Dear Valued TRINAMIC Customer,

due to end-of-life statement from one of our suppliers of components (μ Controller) we would like to inform you of a hardware and firmware change of the following module:

- **TMCM-1110 stepRocker**
- **TMCM-1110_CAN stepRocker**

Changes in TMCM-1110 stepRocker block diagram (yellow marked)

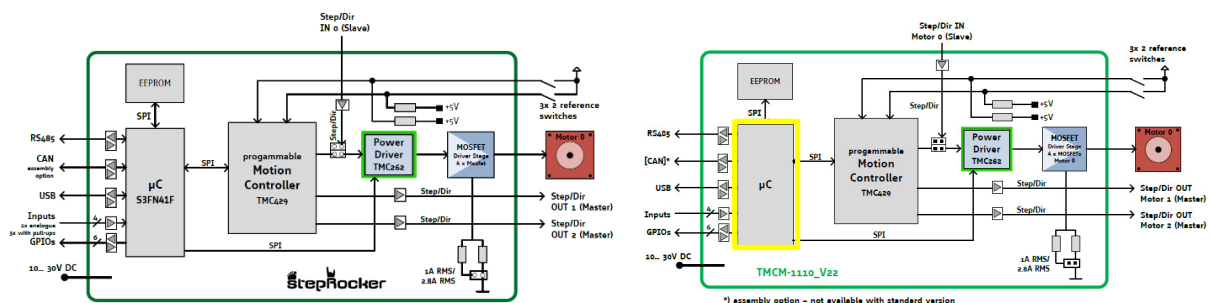
From TMCM-1110 stepRocker PCB V1.3 to V2.3 the following hardware changes have been applied:

- On-board μ Controller: the Cortex-M0 microcontroller has been replaced with a more powerful Freescale Cortex-M4 microcontroller.
- On-board μ Controller: the supply voltage for the μ Controller is +3V3 instead of +5V for the previously used Cortex-M0. Nevertheless, general purpose inputs connected to processor are +5V tolerant and general purpose outputs are level shifted to +5V to maintain maximum compatibility with hardware V1.3.
- USB product and vendor ID will change due to μ Controller update.
- Firmware is transferred from hardware V1.3 to V2.2
- System timing of TMCM-1110 V22 may change due to μ Controller system update.
- Documentation update.
